# Board of Zoning and Planning Staff Report May 23, 2024

1) Application Number: BZAP-23-23

1) Application Number: BZAP-24-12

Address: 319 S. Columbia Ave.

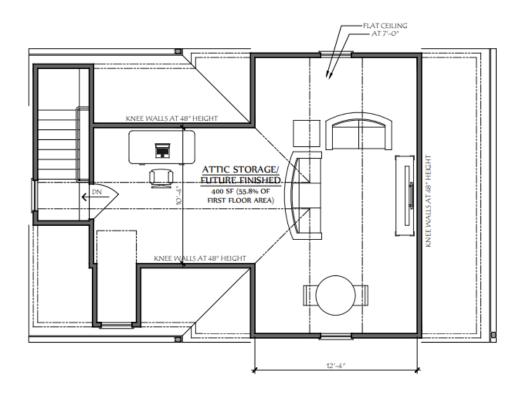
The proposed detached garage is 716sq' and 19'11.5" in height; meeting the size and height limits. The garage is designed with a 2<sup>nd</sup> floor, and a small dormer. The fact that the dormer is in line with the wall below, was not a design concern for the ARB review and was also recommended for approved for a certificate of Appropriate to the BZAP on the consent Agenda. The limit on the 2<sup>nd</sup> floor space exceeds the 50% square foot limit by 5.8%.

The size of the garage is not out of character for the R-3 zoning district. There are  $2^{nd}$  floor windows located in the gable end of the roof and one dormer. All of the windows in the  $2^{nd}$  floor face either the house and the rear property line. It appears that the existing detached garage also has  $2^{nd}$  floor windows.

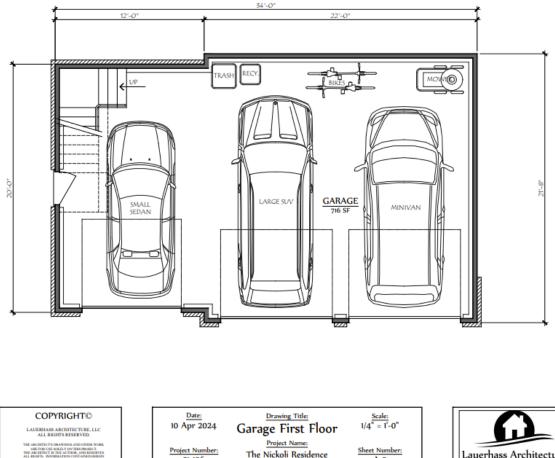
The location of the garage is 3' off the north side property line and 46'8" from the rear property line. It meets the setback requirements for accessory structures and further meets the rear yard setback required for a principal structure (40').
